**PLANNING COMMISSION
STAFF REPORT**

July 18, 2024

AGENDA ITEM: Planning File No. MAJ-23-0004: A final review of a multifamily residential development consisting of three units located at 411 Teller Street.

LOCATION: 411 Teller Street / LOTS 17, 18, & 19, BLOCK 19, FRISCO TOWN SUB

Exhibit B: Tandem Parking and Turning Radius

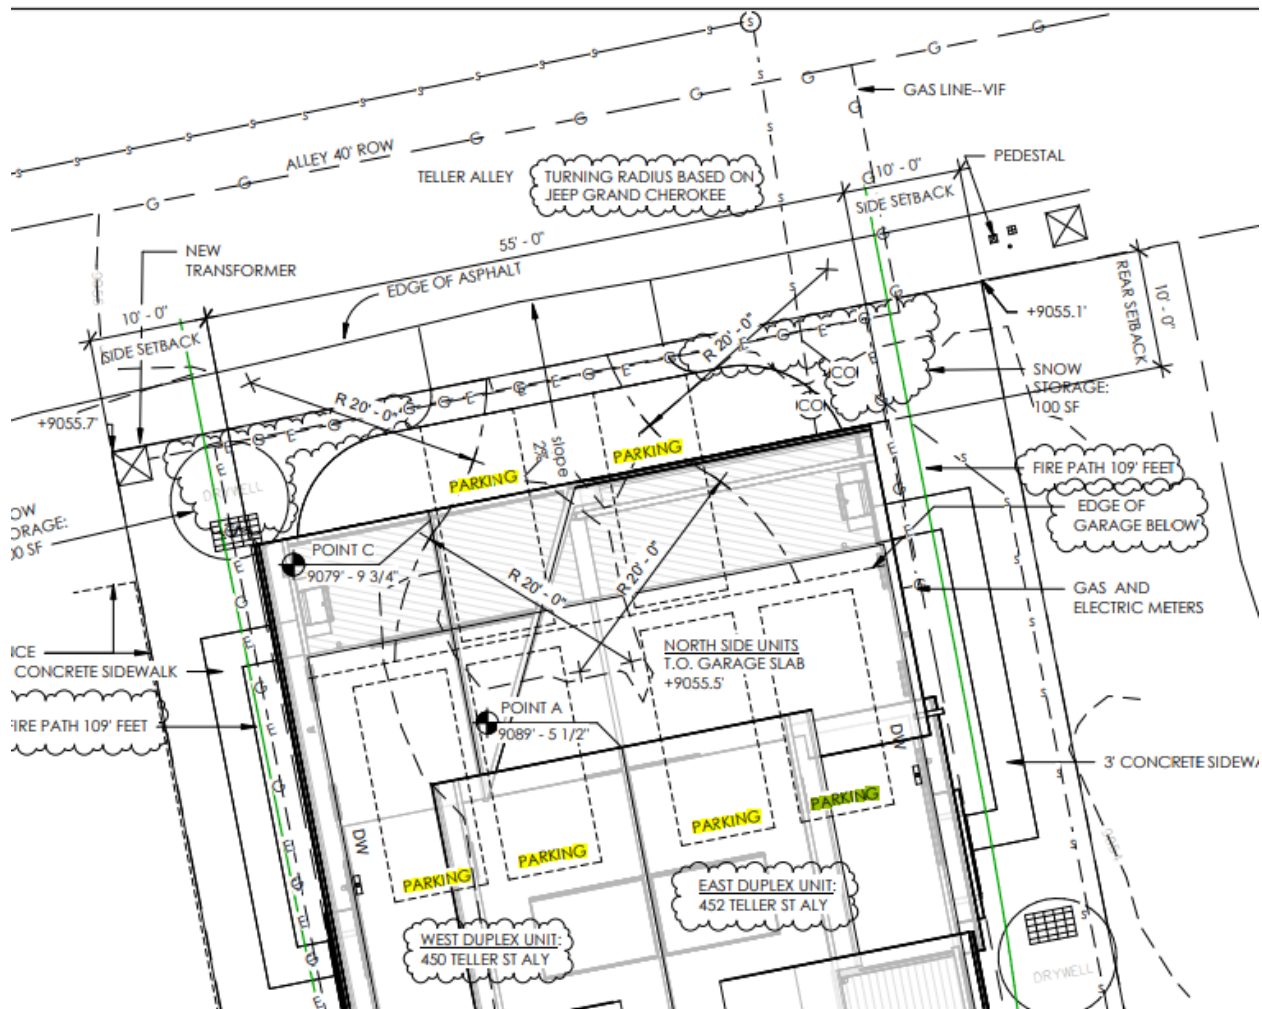
The Applicant is proposing tandem parking for both buildings and has provided a turning radius analysis for one (1) of the parking spaces, shown below.

Exhibit C: Updated Duplex North and South Elevations

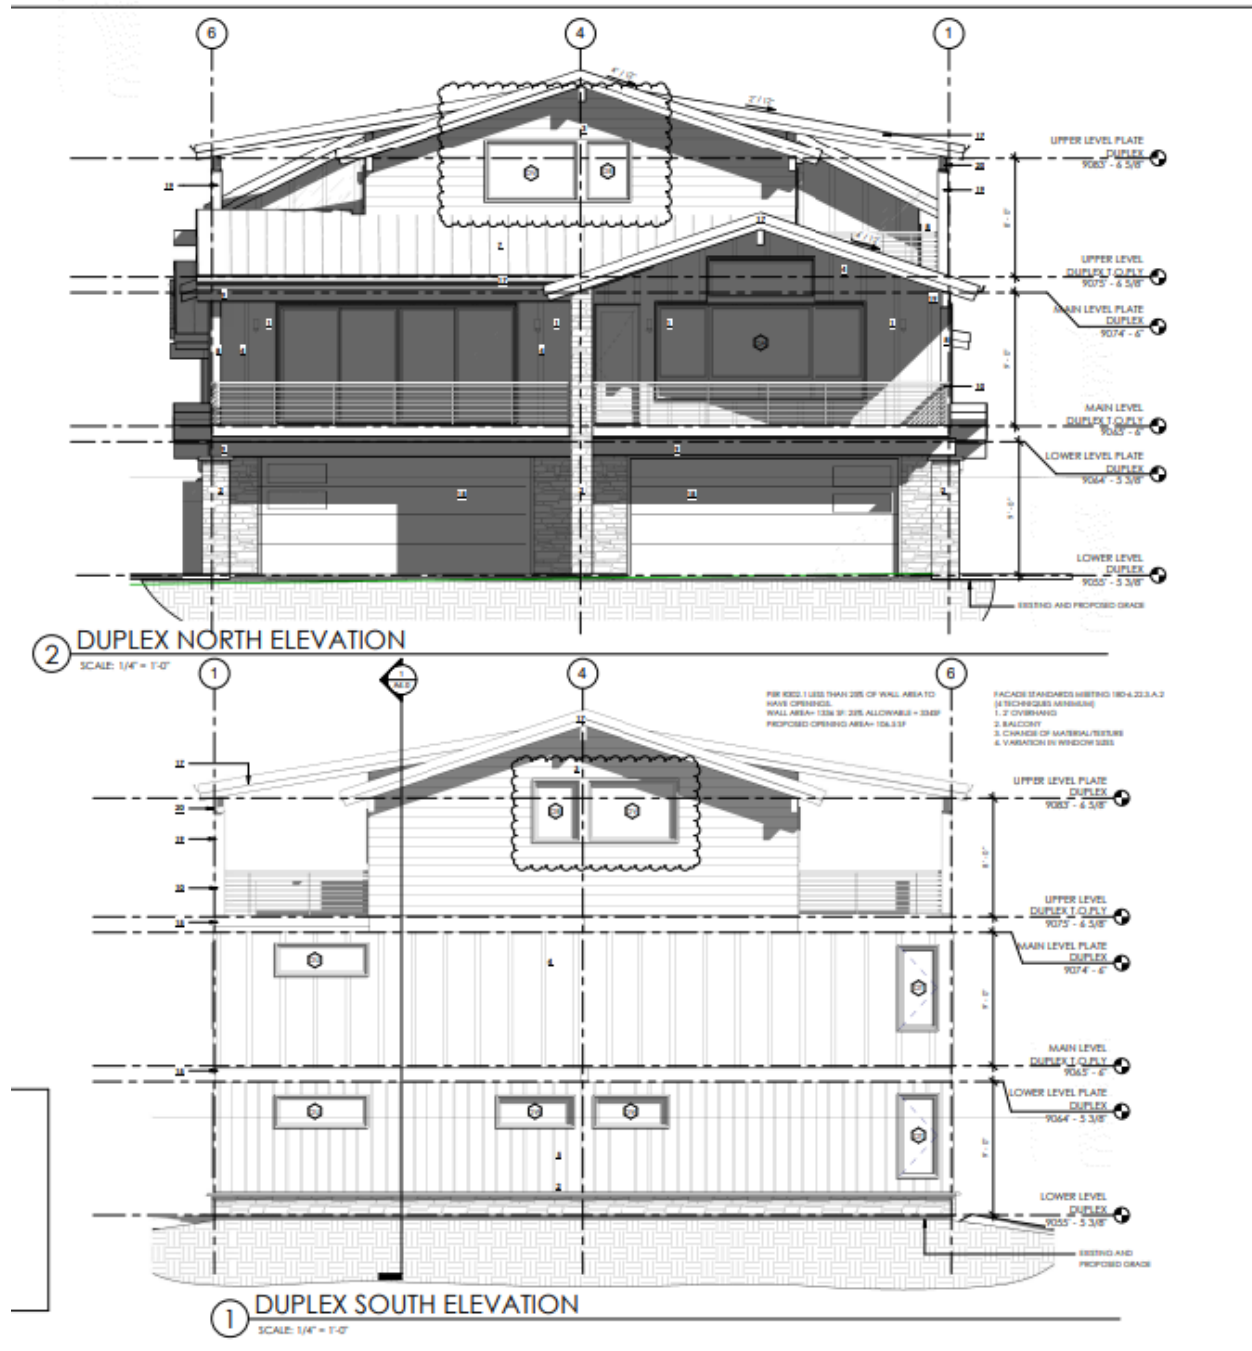
Most facades utilize a variety of building elements, including balconies, changes in materials and texture, variations in window sizes and shapes, and variations in roof forms. At the time of Sketch Plan, the Staff found that two (2) facades did not meet the minimum standards: the duplex south elevation and the single unit north elevation. These facades have been updated in this Application to meet the standard.

Exhibit D: Proposed Bulk Plane Encroachment on The North Elevation

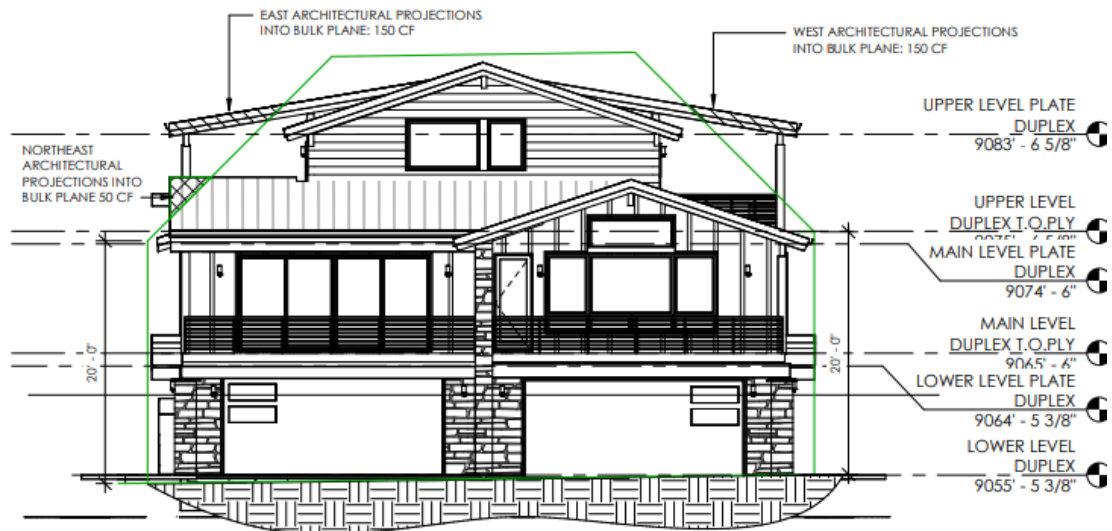
Bulk Standards (§180-6.23): Table 6-K of the Code outlines bulk plane requirements. Building forms may deviate from the bulk plane standards if they do not exceed the maximum building height and provide substantial architectural relief, with Planning Commission approval. The Applicant is proposing 150 cubic feet of bulk plane encroachment.

The Application, as proposed, does not exceed the maximum building height and provides substantial architectural relief. The Application is meeting this standard.
